STAGE 1 ROAD SAFETY  
AUDIT

**Maughanaclea Renewable Energy  
Development**  
Stage 1 Road Safety Audit

# Maughanaclea Renewable Energy Development

## Stage 1 Road Safety Audit

Figure 2.1 – Location Where Passing Motorists Could Access the Overrun Area (When Not in Use)

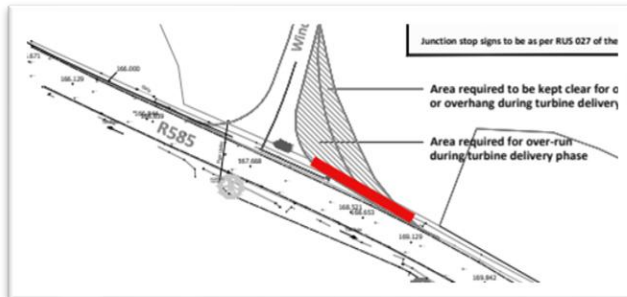
### 2.1 Problem: Passing Motorists Accessing Vehicle Overrun Area

**Location:** Junction A | Existing mainline carriageway to the east of the site

The over-run area might create confusion for passing motorists, who could access the overrun area by mistake, leading to sudden braking, loss of control or conflicts with construction traffic.

The Designer should ensure that a suitable barrier is put in place to prevent passing motorists from accessing the abnormal load overrun area when it is not in use.

2.1	Yes	Yes	A suitable barrier will be put in place at all times during the construction stage and opened only on the nights that the abnormal loads are delivered. On these occasions the deliveries will be accompanied by a Garda escort and the opened junction will be attended by site staff. On the completion of construction the over-run areas will be closed off permanently.	Yes

Figure 2.3 – Location Where Passing Motorists Could Access the Overrun Area (When Not in Use)

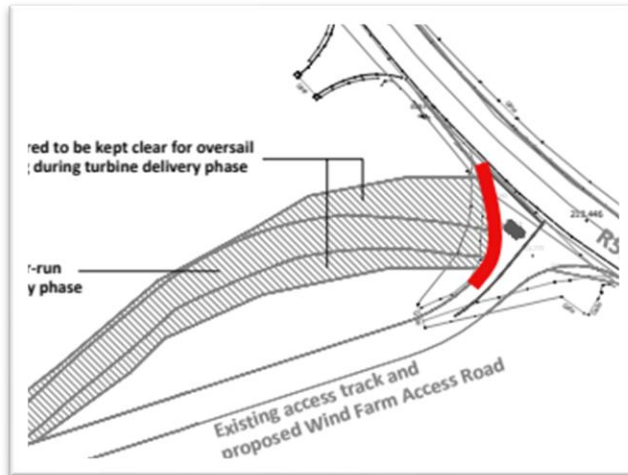
## 2.3 Problem: Passing Motorists Accessing Vehicle Overrun Area

**Location:** Junction B | Existing mainline carriageway to the south of the site

The over-run area might create confusion for passing motorists, who could access the overrun area by mistake, leading to sudden braking, loss of control or conflicts with construction traffic.

The Designer should ensure that a suitable barrier is put in place to prevent passing motorists from accessing the abnormal load overrun area when it is not in use.

2.2	Yes	Yes	It is confirmed that the visibility splays described and shown in Figure 15-25 will be provided at all times.	Yes
2.3	Yes	Yes	The same response provided to 2.1 applies.	Yes

Figure 2.6 – Location Where Passing Motorists Could Access the Overrun Area (When Not in Use)

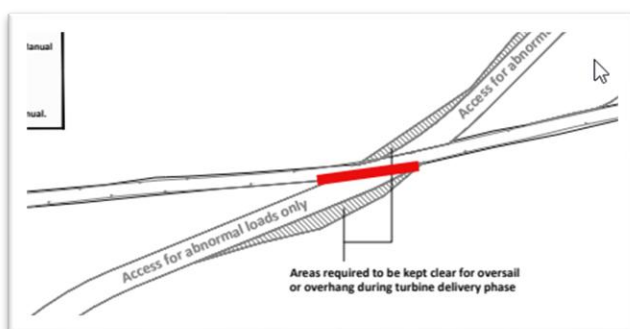
## 2.6 Problem: Passing Motorists Accessing Vehicle Overrun Area

**Location:** Junction C | Existing mainline carriageway to the east of the site

The over-run area might create confusion for passing motorists, who could access the overrun area by mistake, leading to sudden braking, loss of control or conflicts with construction traffic.

The Designer should ensure that a suitable barrier is put in place to prevent passing motorists from accessing the abnormal load overrun area when it is not in use.

2.6	Yes	Yes	A suitable barrier will be installed at all times and opened only on the nights that the abnormal loads are delivered	Yes
2.7	Yes	Yes	It is confirmed that the vertical alignment has been checked for visibility and at all junctions. The attached Sketch A shows that visibility splays are provided from a driver height of 1.05m to an object height of 1.05m to the extent of the 90m visibility splay required in both directions.	Yes

Figure 2.8 – Location Where Passing Motorists Could Access the Overrun Area (When Not in Use)

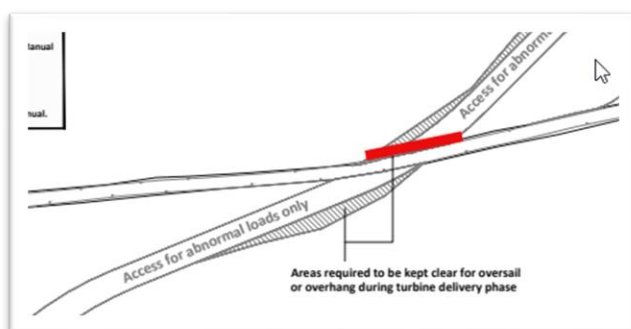
## 2.8 Problem: Passing Motorists Accessing Vehicle Overrun Area

**Location:** Junction D | Existing mainline carriageway to the west of the site

The over-run area might create confusion for passing motorists, who could access the overrun area by mistake, leading to sudden braking, loss of control or conflicts with construction traffic.

The Designer should ensure that a suitable barrier is put in place to prevent passing motorists from accessing the abnormal load overrun area when it is not in use.

2.8	Yes	Yes	A suitable barrier will be installed at all times and opened only on the nights that the abnormal loads are delivered.	Yes

**Figure 2.9 – Visibility Splays Partially Obscured in Both Directions at Site Entrance D**

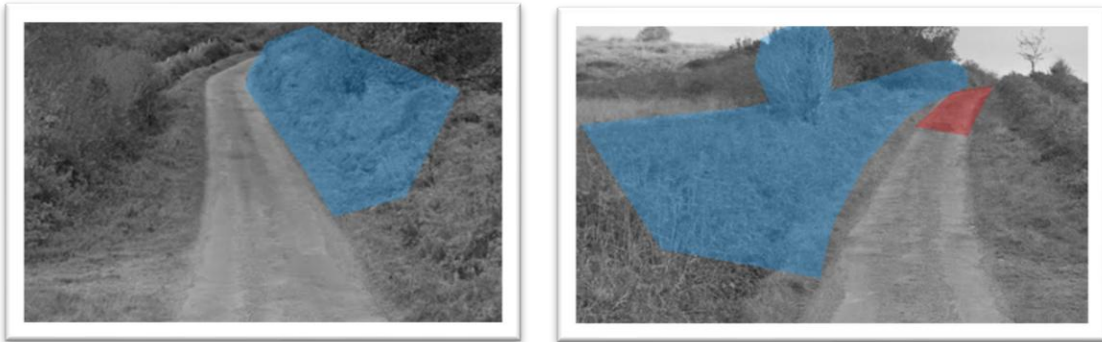
## 2.9 Problem: Visibility Splays Partially Obscured

**Location:** Junction D | Existing boundary treatments either side of access

Drivers attempting to leave the access will have their line of sight partially blocked in both directions by the existing field boundary, and by the crest of the L8777 road to the left. This could increase the risk of side-impact collisions at the access.

The site access arrangements should be modified to ensure that an appropriate level of visibility can be provided for drivers exiting the access

Problem Reference (Section 2)	Designer Response Section			Audit Team Response Section
	Problem Accepted ( yes / no )	Recommended Measure Accepted ( yes / no )	Alternative Measures or Comments	Alternative Measures Accepted ( yes / no )
2.9	Yes	Yes	The required 90m visibility splays in the horizontal plane shown in Figure 15-35 will be provided at all times and Sketch B shows that visibility splays are available from a driver height of 1.05m to an object height of 1.05m to the extent of the 90m visibility splay required.	Yes
